**From:** jeff taylor [REDACTED]  
**Sent:** 12 April 2016 16:02  
**To:** Glyn Rhonwy Pumped Storage Scheme  
**Subject:** WRITTEN REPRESENTATION REGARDING THE ISSUE OF FLOOD RISK

**Glyn Rhonwy Pumped Storage EN010072**  
**WRITTEN REPRESENTATION REGARDING THE ISSUE OF FLOOD RISK**  
**12<sup>th</sup> April 2016**  
**FROM JEFF TAYLOR ON BEHALF OF THE GROUP “CONCERNED ABOUT**  
**GLYNRHONWY”**  
**Reference number: 10031989**

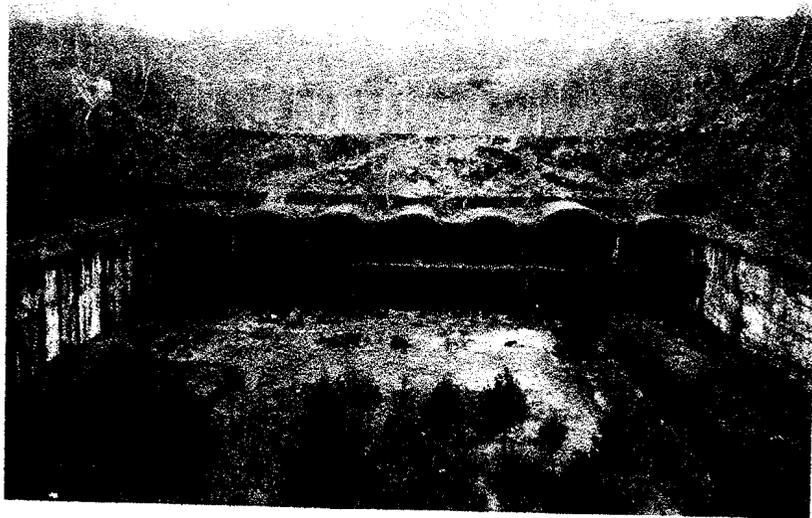
Residents downstream of the Dinorwig scheme, along the Afon Seiont, are already subject to rapid river level changes from unannounced releases of water into the system. Flooding events are becoming more frequent as a result of climate change. And pumped storage schemes on both sides of the valley are likely to be experiencing the need to discharge excess water at the same time as the whole area is experiencing flooding, thereby exacerbating the problem. There is no mention of coordinating discharges with the commercial competitor company across the valley. These issues are not addressed in the Developers documentation for Glyn Rhonwy scheme.
